From: <tfohara@dukeengineering.com>
To: Goutam Bagchi <GXB1@nrc.gov>
Date: Wed, Mar 29, 2000 4:10 PM
Subject: Some thoughts on draft technical document & truncation

Comments on NRC "Draft Final Technical Study of Spent Fuel Pool Accident Risk at Decommissioning Plants" – February 15,2000**Summary of NRC Draft**

Comments on Appendix 2b Structural Integrity of Spent Fuel Pools Subject to Seismic Loads (Reference 1)**1. Introduction**

Figure 1 – Distribution of Upper Bound Magnitude Estimates from Reference 1 for a New England site.

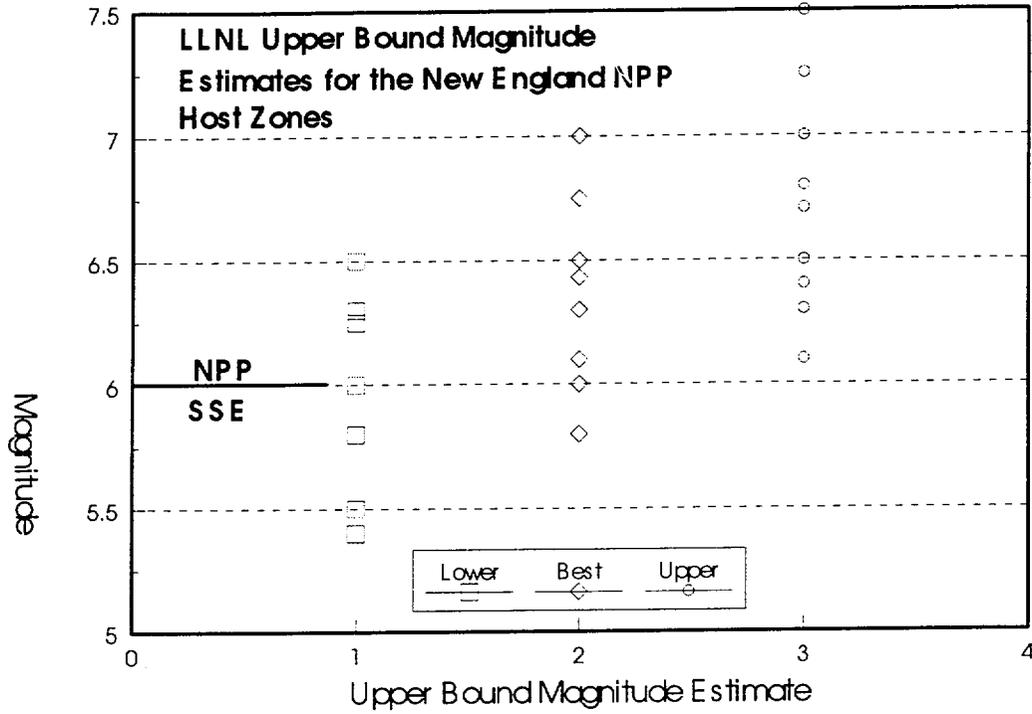
References 2 and 3 describe the Lawrence Livermore National Labs (LLNL) and Electric Power Research Institute (EPRI) seismic hazard methodologies. A seismic hazard analysis (SHA) estimates the seismic hazard at a site due to the potential occurrence of earthquakes in the region surrounding the site. Importantly, the historic seismic data is insufficient, at least for the CEUS, to use as the sole source of information for estimating the various parameters of the overall probability model. Therefore, it is necessary to rely on "expert opinion" to supplement the data. One fundamental expert opinion input to the SHA is the upper bound magnitude distribution for each earthquake source. Figure 1 contrasts the distribution of upper bound magnitude estimates assessed by the experts in the LLNL study for the host zones containing a New England NPP with the SSE determined by the 10CFR Part 100 Appendix A process. This distribution of upper bound magnitude is typically based on "expert opinion" – not on any known structure in each host zone description that could cause earthquakes this large. Within this context, the assessed seismic hazard will generally be higher – because less is known and the distribution has more probability associated with extreme outcomes, **or, outcomes that in fact cannot occur.** The effect of including these extreme outcomes is to predict incredible ground motions at credible probability levels. Expert opinion on the distribution of upper bound magnitude is but one of the many opinions rendered in the LLNL and EPRI studies that have profound effects on the perceived seismic hazard at low (10^{-6}) probability levels.

Figure 2 Effect of Attenuation Random Uncertainty on Probability of Exceedance from a Point Source

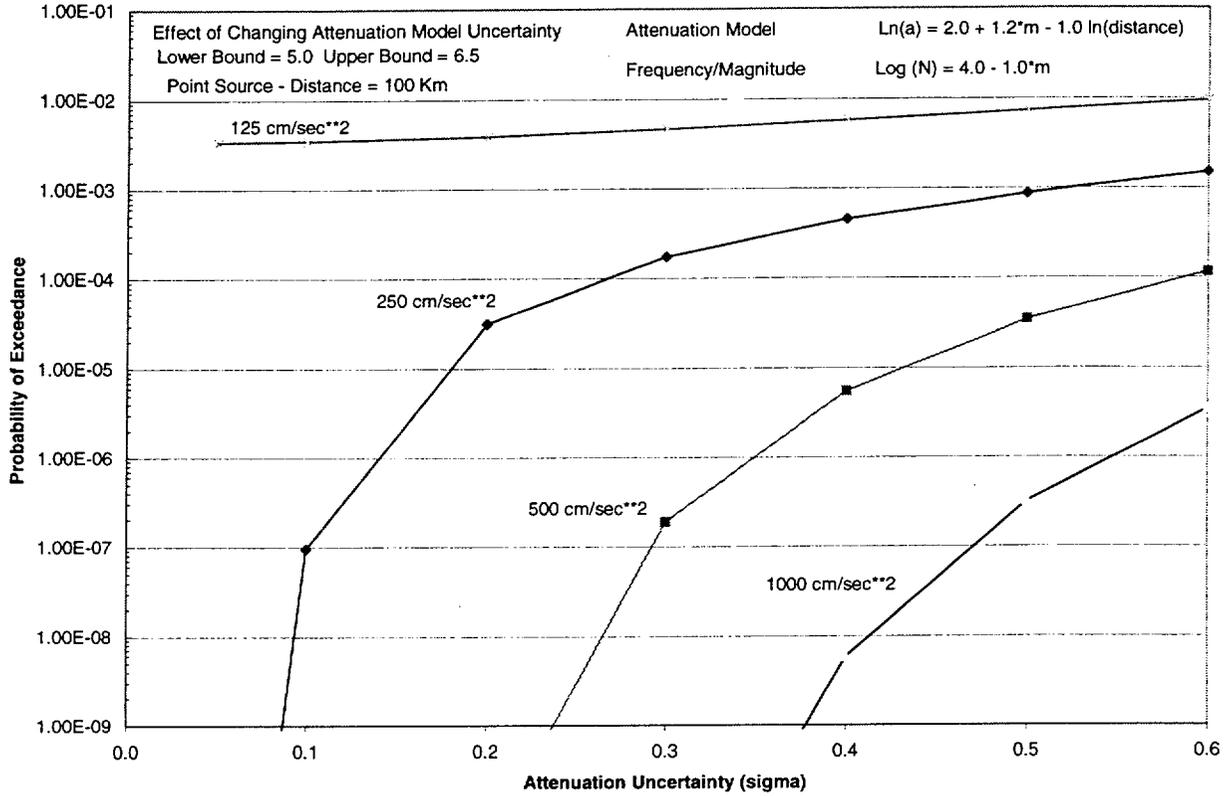
Goutam - attached are some comments on the draft technical document. Included in the text is a discussion on the effect of the attenuation model random uncertainty term. I was able to analytically model a point source and show the effect of how changes in sigma change the probability of exceedance at various ground motion levels. The bottom line is that at high ground motions, the probability of exceedance is driven by the extreme tail of the distribution.

It was noted previously that a 0.5g HCLPF relates to about a 1 g median SFP capacity. When rigorously convolving a typical mean seismic hazard curve with the SFP fragility curve associated with a 0.5g HCLPF, the dominant contribution to the seismic risk occur above about 0.7g. Based on this information, only large earthquakes can generate ground motions of the amplitude, frequency content, and duration to challenge the seismic capacity of spent fuel pools. However, at high ground motion values (1g), the tail of the attenuation random uncertainty distribution (sigma) allows, with some non-negligible probability, relatively small events to contribute to the probability of exceeding a ground motion of 1g. Deterministic evaluation performed in the licensing of CEUS NPPs have not identified any sources near NPPs that are capable of generating earthquake ground motions of this magnitude. Therefore, these probabilistic results don't make sense and provide a basis for truncating the tail of the random uncertainty term at high ground motion values or using a smaller value for the random uncertainty term at high ground motions.

Figure 3 – Annual Probability of Exceeding the SSE at CEUS sites based on EPRI (Reference 3)

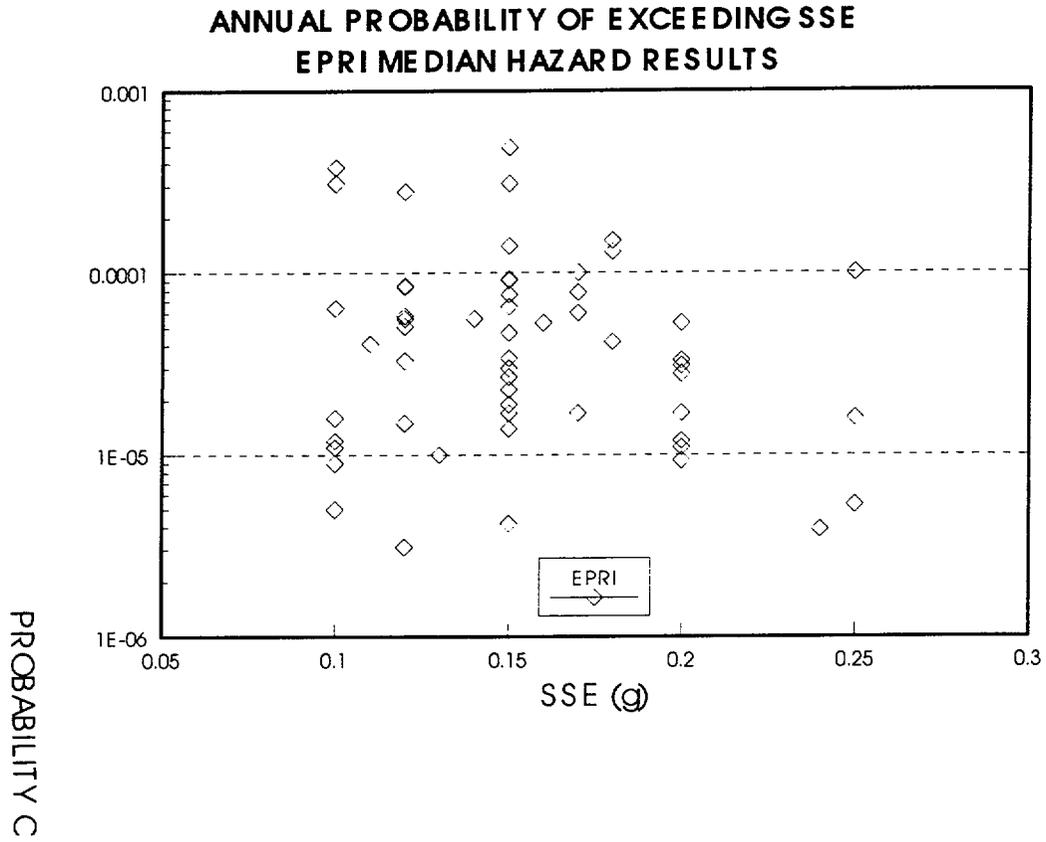
earthquakes to the overall seismic hazard, not on the absolute effect. Also, comparisons between the LLNL and EPRI results was typically made at the SSE level (0.15g to 0.25g - annual probability of 10^{-3} to 10^{-4}), not at the ground motion level associated with a HCLPF of 0.5g. It is noted that given a HCLPF of 0.5g the median capacity (A_m) of an SFP is about 1.0g ($A_m = \text{HCLPF}/e^{-1.65(Bc)}$) – far from typical SSE values. Realistically, only large Charleston like earthquakes can generate ground motions of the amplitude, frequency content, and duration to challenge the seismic capacity of spent fuel pools. However, at high ground motion values (1000 cm/sec^2), the tail of the attenuation random uncertainty distribution (sigma) allows, with some non-negligible probability, relatively small events to contribute to the probability of exceeding a ground motion of 1000 cm/sec^2 . Figure 2 shows the effect of changing sigma for a point source at a given distance. These results were analytically determined. As can be seen, at low ground motions (125 cm/sec^2), changes in sigma have a small effect on the probability of exceedance. However, at high accelerations (1000 cm/sec^2) the effect of changes in sigma is profound. The high probability of exceeding 1000 cm/sec^2 based on use of a sigma of 0.6g in Figure 2, is driven by the tail of the attenuation random uncertainty term. For example, 1000 cm/sec^2 is about 3 standard deviations above the expected ground motion from a magnitude 6.5 earthquake at 100 km. Deterministically, these results don't make sense and provide a basis for truncating the tail of the random uncertainty term at high ground motion values. Use of a smaller sigma value is a form of truncation. As can be seen on Figure 2, the probability of exceeding 1000 cm/sec^2 is reduced by about a factor 600 by simply changing sigma from 0.6 to 0.4. EPRI results are based on use of a sigma of 0.5. Based on this information and information previously described in Reference 5, use of the LLNL probabilistic estimates at low probability values may not be credible. EPRI results are also likely to be overly conservative at high ground motion values.
